**AMENDMENT TO SOLICITATION**

**AMENDMENT NO. 2**

**SOLICITATION NO. B2025-04-04**

**PROJECT: Sky Tykes**

**2** LIGHT POLE FOUNDATION DETAIL  
NOT TO SCALE

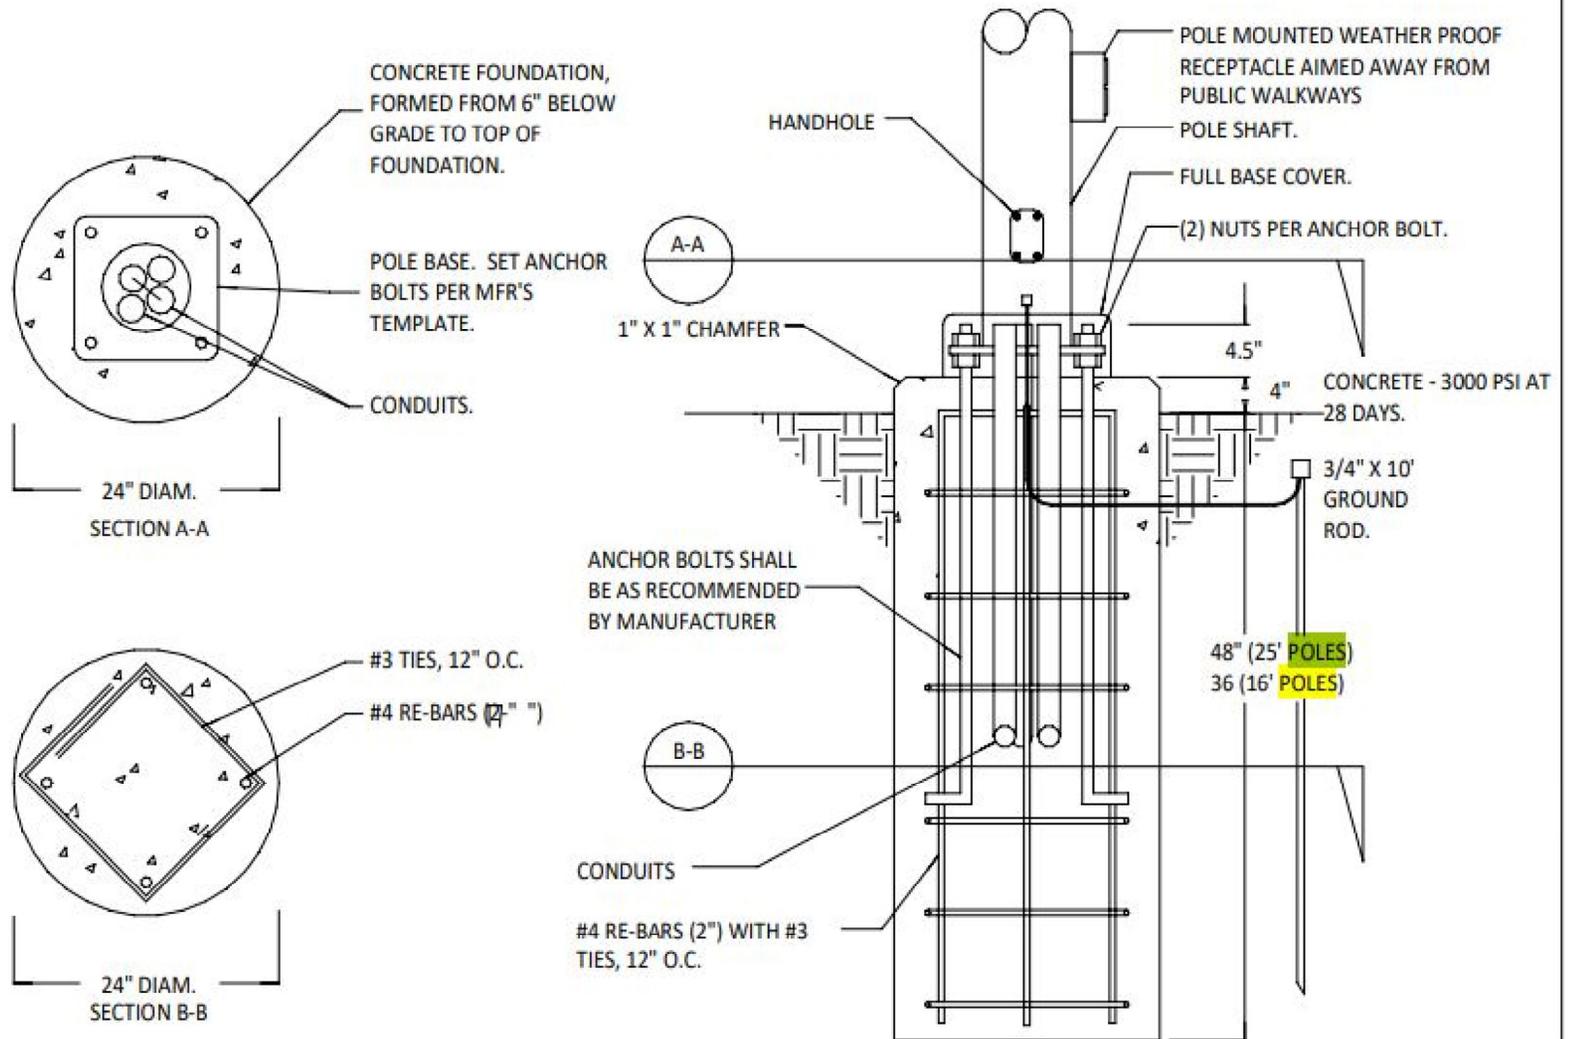
**QUESTION 11): Are the posts 12 ft posts with 4 ft buried in the ground?**

**ANSWER 11):** Yes; see attached drawing
